Applicable Urban Design Priorities Project Should Achieve

2121 Flora St.

Neighborhood: Dallas Arts District

Program: Retail/Residential 47 residential units 8356 sqft. retail

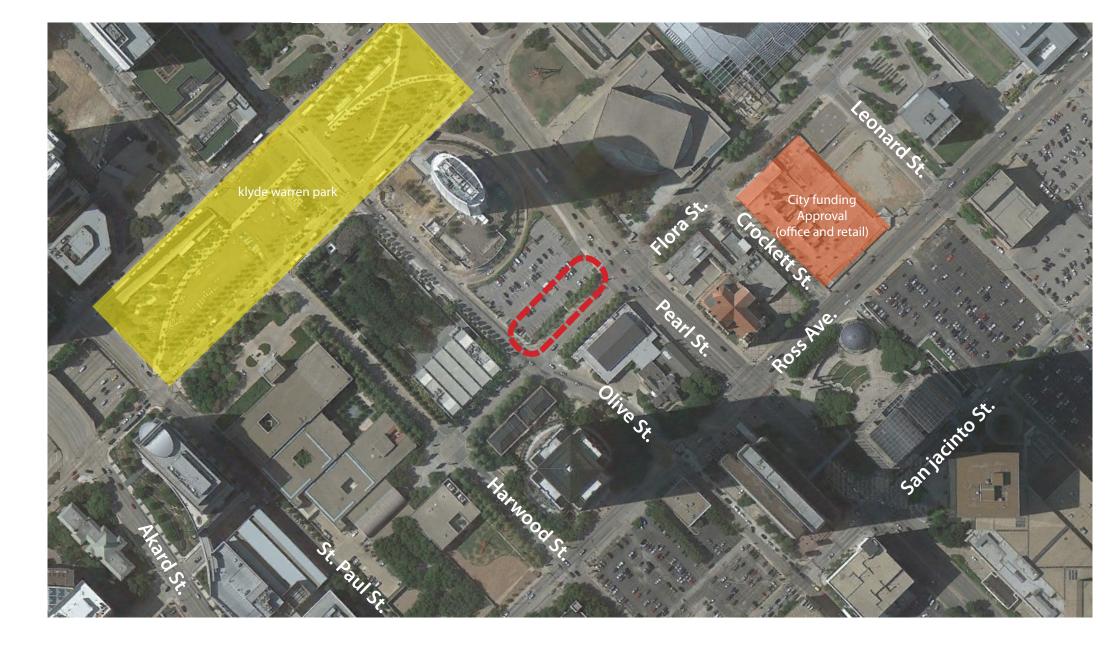
- [1] Creating a consistent street edge along Flora Ground floor elevation should maintain a high level of transparency and offer uses that foster pedestrian activity on the street. Entryways should be visually prominent, with attention given to visually marking public entrances through materials and/or awnings. Specific attention should be given to the ground level facade of the building as it transitions to both Pearl and Olive streets which offer direct connections to Klyde Warren Park.

- [2] Maintain an inviting, cohesive pedestrian sidewalk at proposed garage entry stair- Proposed garage entry should incorporate the same quality of materials as the entire building facade. Special care should be given toward creating a well lit, inviting pedestrian entrance.

- [3] Coordination with the Office of Sustainable Development and Planning is required to meet the design criteria as outlined in the Dallas Arts District Sasaki Plan As the development in the Dallas Arts District should conform to the Dallas Arts District Sasaki Plan, design recommendations will need to be coordinated and approved with the appropriate decision makers in the Office of Sustainable Development and Planning.
